Subject: IHP PC 14 – Information requested by IHP
Sent: 24/04/2024, 8:59:06 am
From: Collins, Faye<Faye.Collins@ccc.govt.nz>
To: IHP Info
Attachments: [WithQMs.pdf](#)
[NotifiedHighDensityRes.pdf](#)
[RiccartonBushExtended.pdf](#)
[scan_map_collinsf_2024-01-18-11-03-49_\(007\).pdf](#)

During the course of the Hearings on Plan Change 14 and the Board's appearances the Panel has requested that the Board supply maps illustrating some of the matters raised in its presentations. While some of these may have been previously sent they are attached again for completeness.

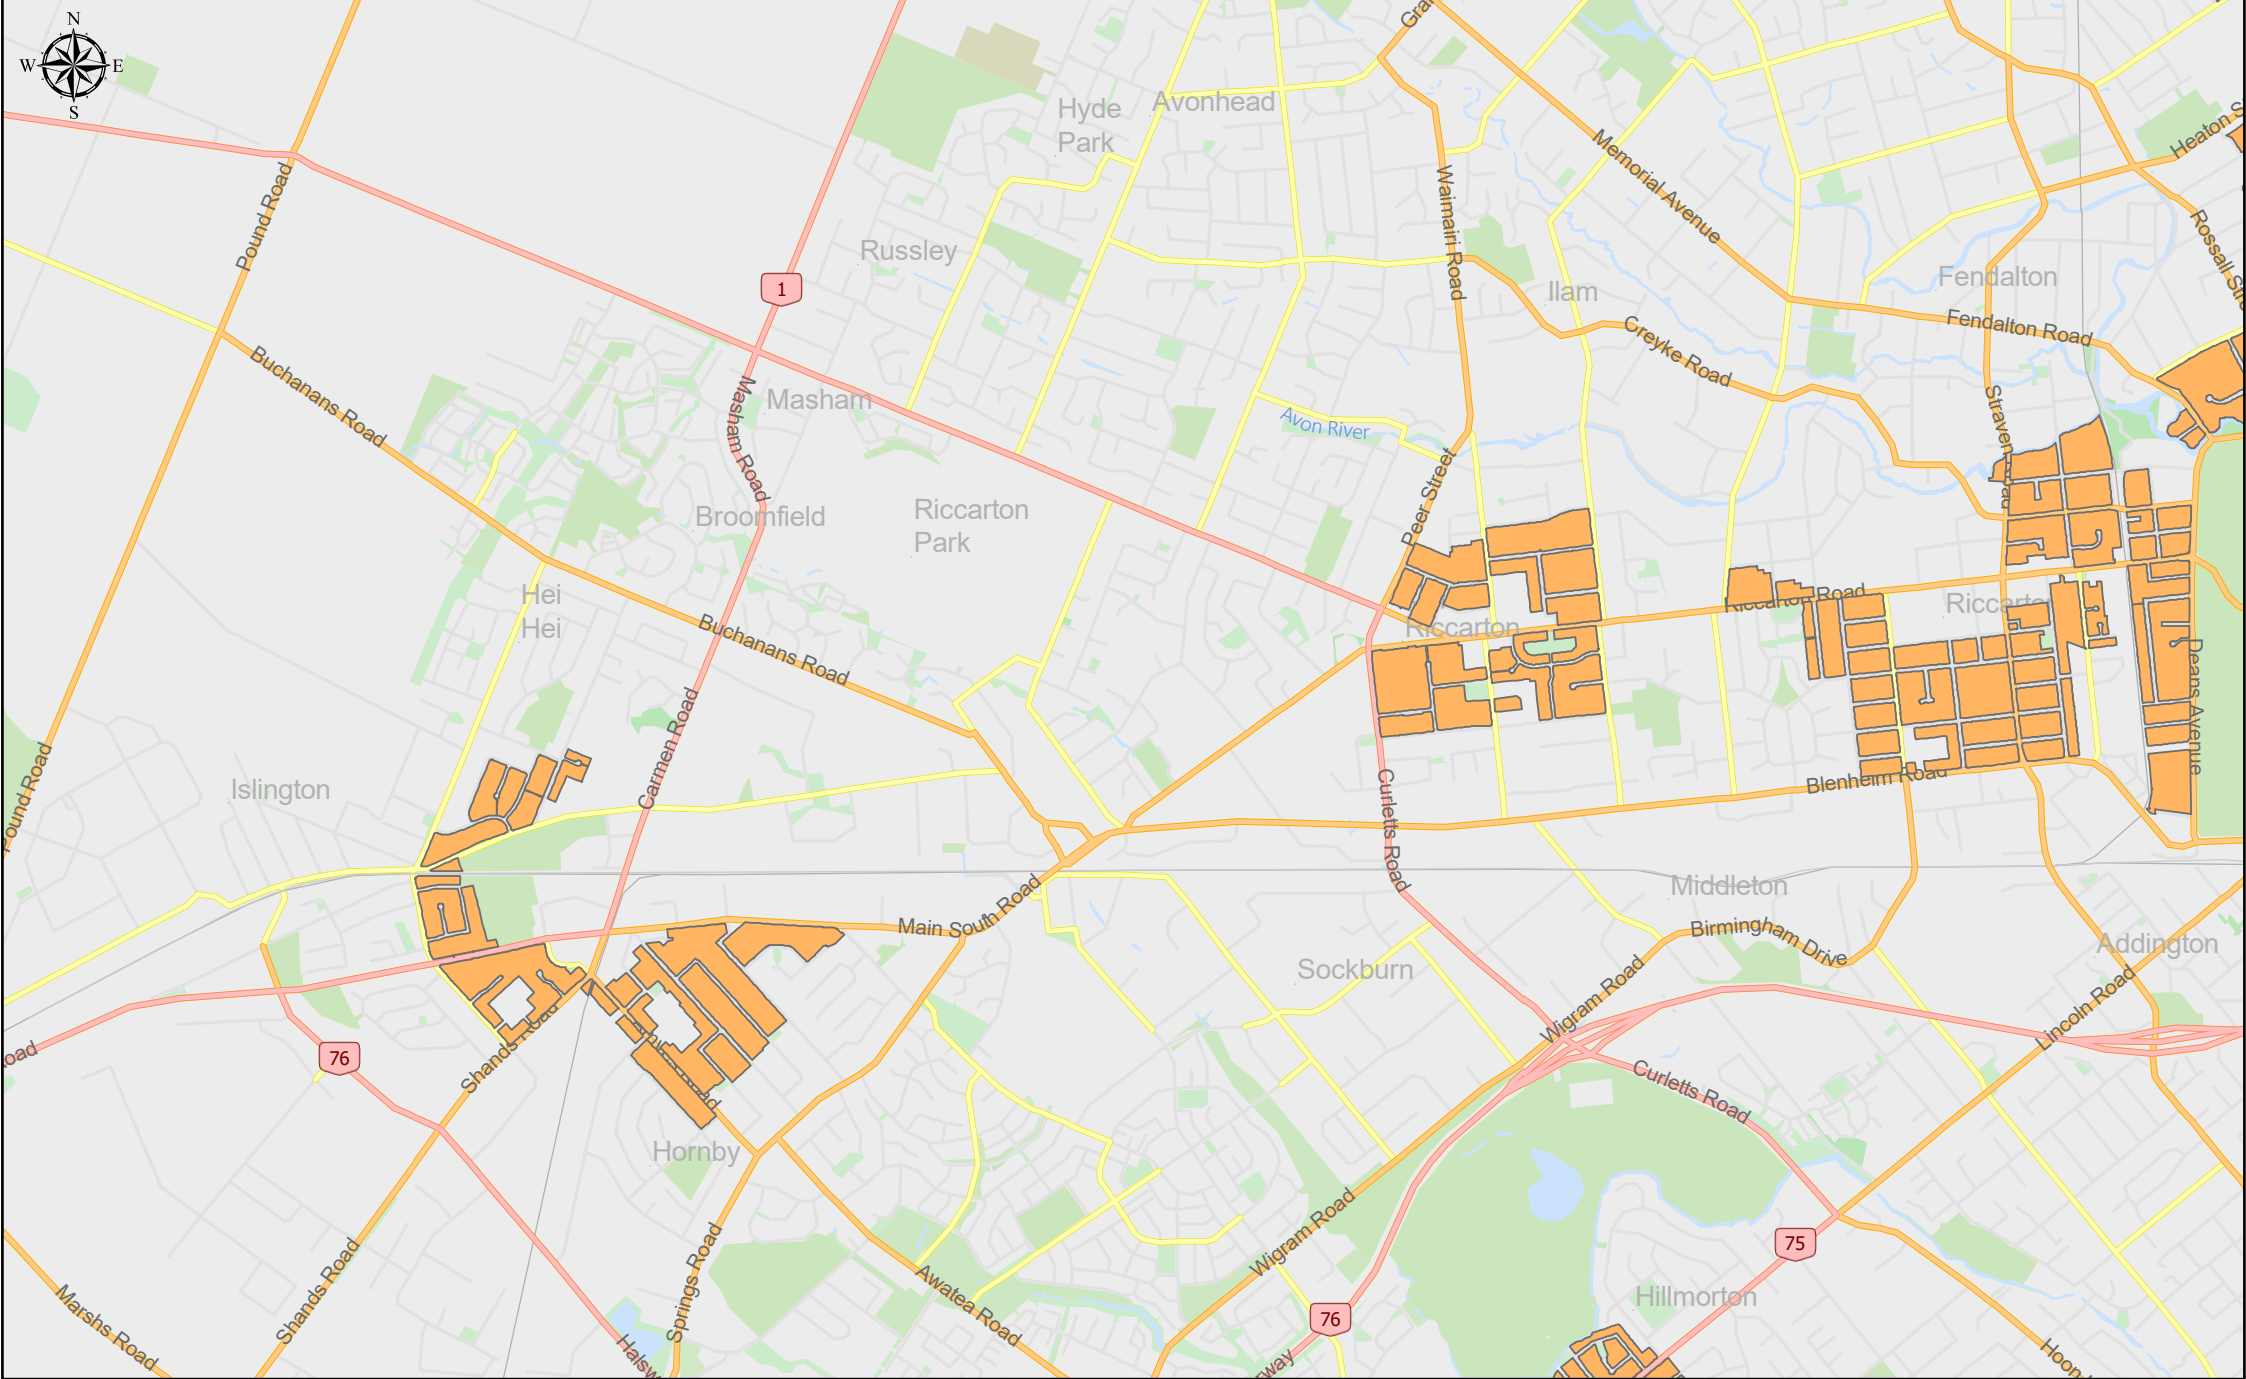
- A Plan showing the area between Deans Avenue through to Hornby marked to show Airport Noise Influence Area excluding areas covered by other qualifying matters.

Notified High Density Residential Zone - Deans Ave to Hornby

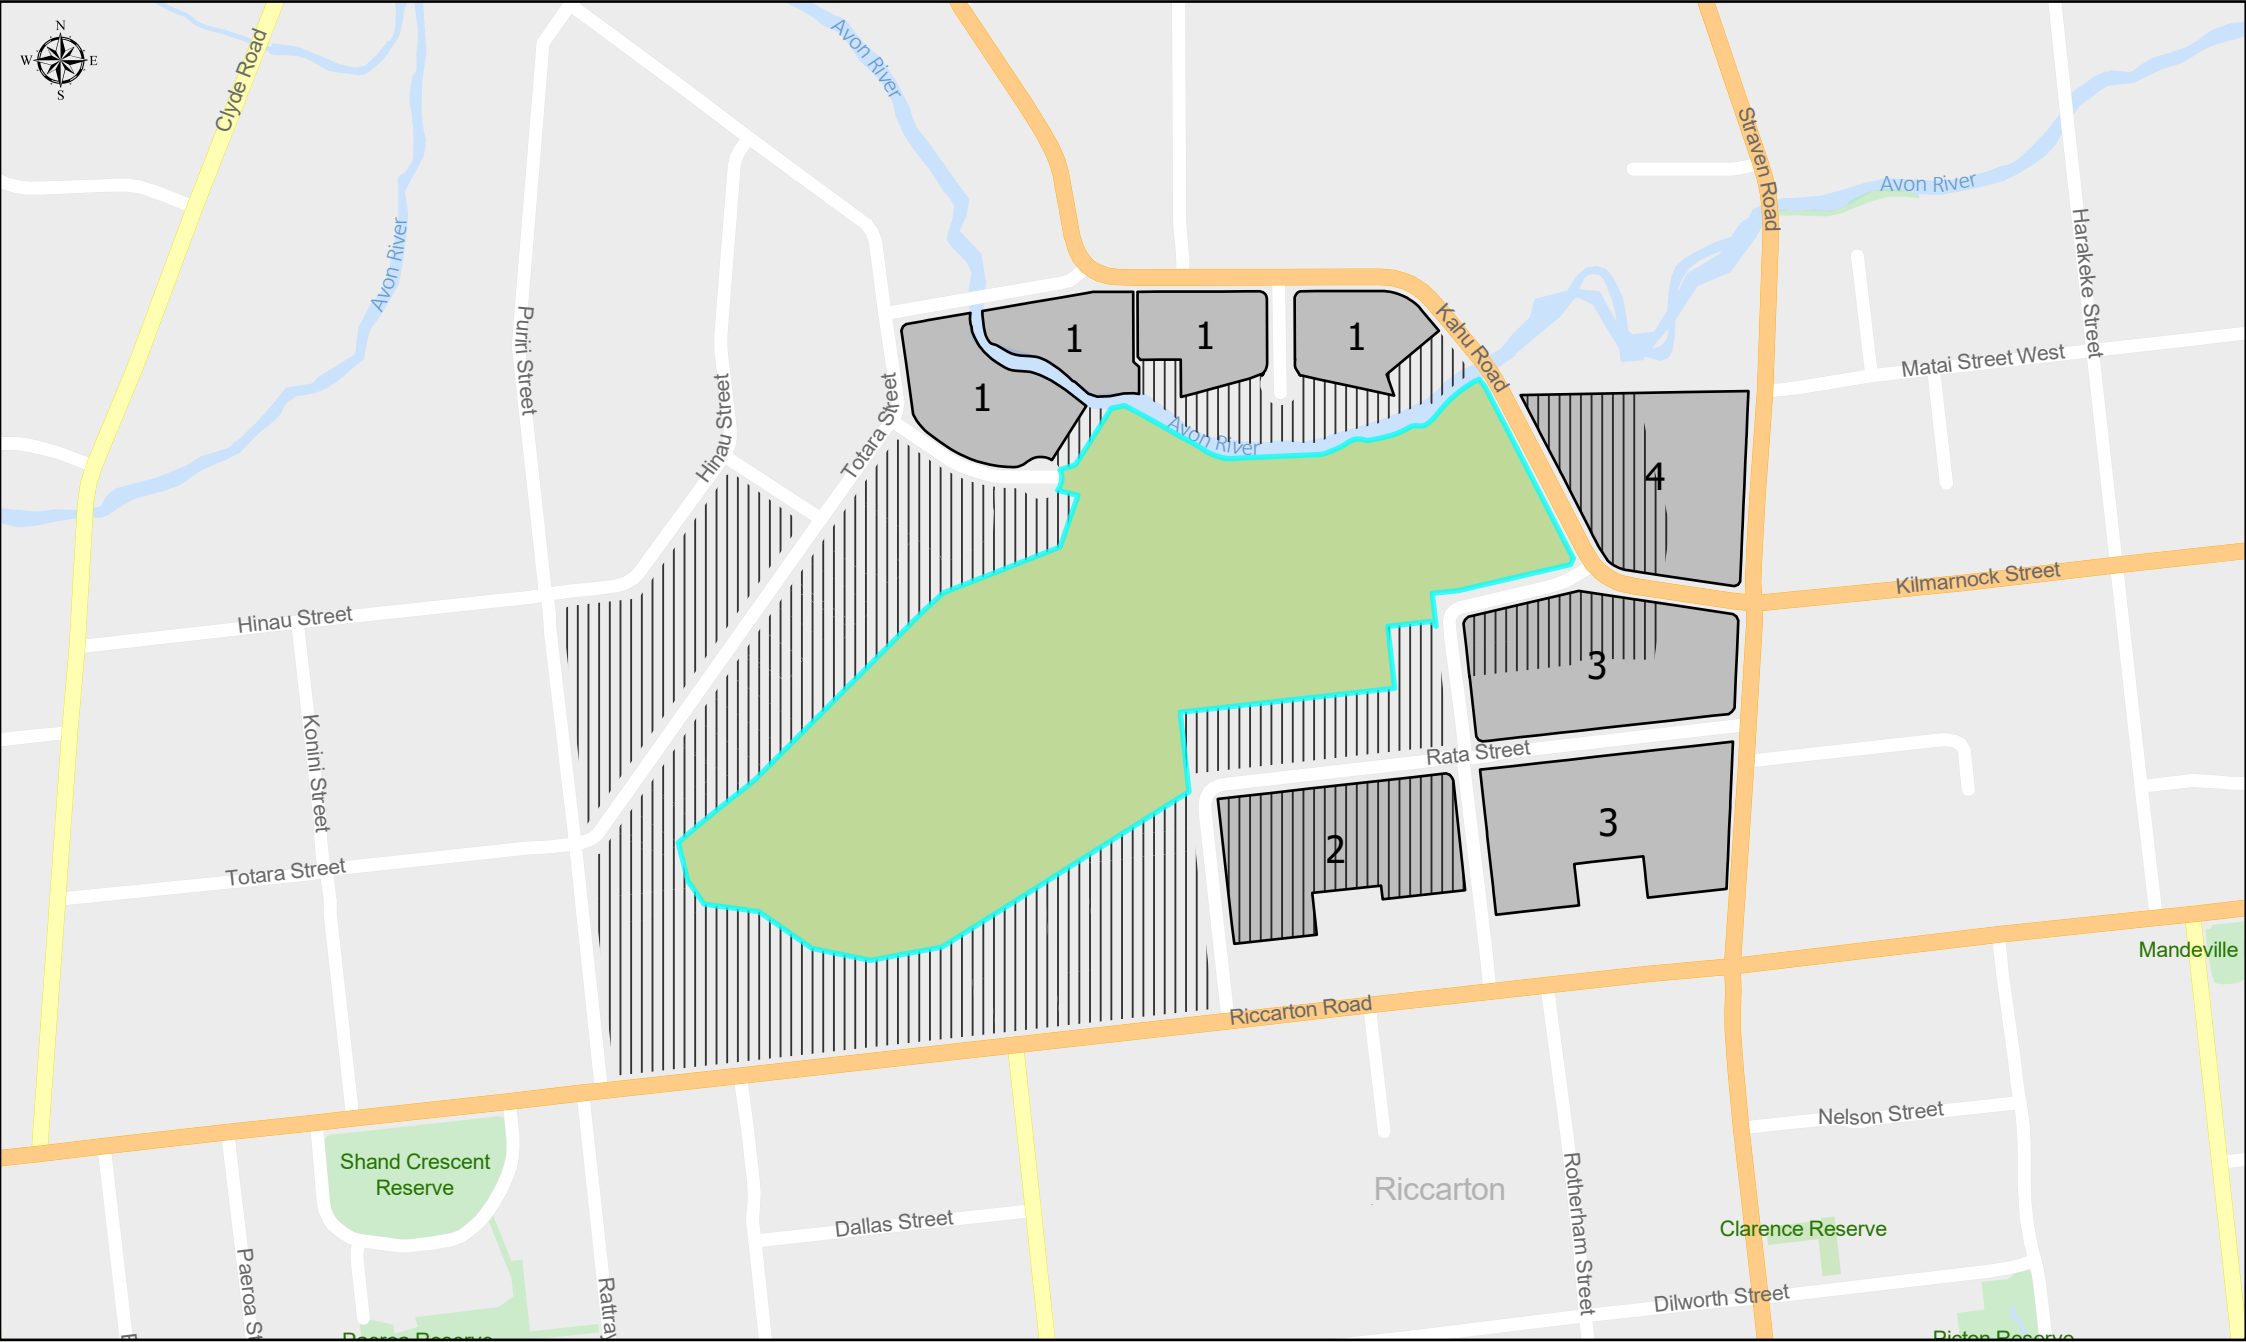
- A Plan showing the area between Deans Avenue through to Hornby marked to show Notified High Density Residential Zones without qualifying matters – during her presentation the Board the Chairperson spoke of a wall of six storey buildings between Deans Avenue and Hornby, however, the map shows that the wall will largely be between Deans Avenue and Peer Street in Riccarton (without qualifying matters some areas surrounding Riccarton Bush may have been included). The Chairperson apologises for her inaccurate statement.

- A Plan showing the Extended Riccarton Bush Interface area sought by the Board. – The Board is seeking that the areas labelled 1 (Kahu Road in vicinity of Boys High School) be included in RBI Area for coherency and that the areas labelled 2,3, and 4 retain existing suburban density zoning. Note area 2 is medium density with height controls. The Board requests that it remain suburban density.

* Area 1: The area of Kahu Road in vicinity of Boys High School to be included in RBI Area for coherency

Areas 2-4: To retain existing suburban density zoning
